Project	IEEE 802.16 Broadband Wireless Access Working Group < http://ieee802.org/16 >	
Title	DL subchannelization for OFDM mode	
Date Submitted	2004-05-20	
Source(s)	Tal Kaitz et al. Alvarion Ltd. 21 A Habarzel St. P.O. Box 13139, Tel-Aviv 61131, Israel	Voice: +972-36457834 Fax: +972-36456222 mailto:tal.kaitz@alvarion.com
Re:	802.16e/D2 Letter Ballot	
Abstract	The document contains Sponsor Ballot comment information	
Purpose	The document is contributed to support certain comment on 802.16REVd/D4 Sponsor Ballot	
Notice	This document has been prepared to assist IEEE 802.16. It is offered as a basis for discussion and is not binding on the contributing individual(s) or organization(s). The material in this document is subject to change in form and content after further study. The contributor(s) reserve(s) the right to add, amend or withdraw material contained herein.	
Release	The contributor grants a free, irrevocable license to the IEEE to incorporate text contained in this contribution, and any modifications thereof, in the creation of an IEEE Standards publication; to copyright in the IEEE's name any IEEE Standards publication even though it may include portions of this contributio

Figure 1 Format of DL Subchannelization section

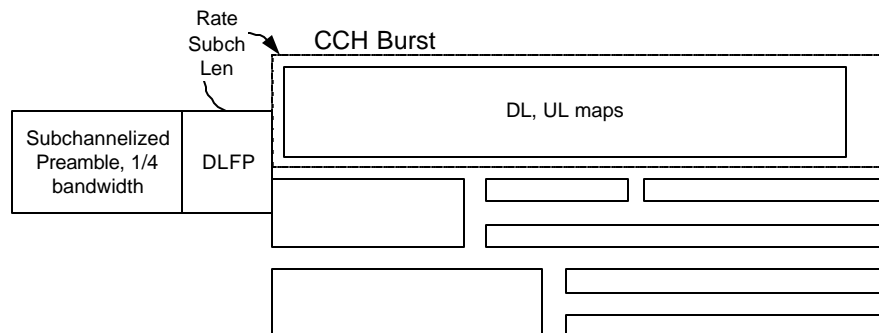
The DL subchannelization zone is shown in Figure 1.

The zone commences with a subchannelized preamble followed by a subchannelized FCH burst. The FCH is transmitted using QPSK $\frac{1}{2}$. The FCH is transmitted over the $\frac{1}{4}$ of the bandwidth. The carrier allocation is as given in table 211 (OFDM symbol parameters). The subchannel index of the FCH is derived from the 2 LSB of the BSID as in table XXX.
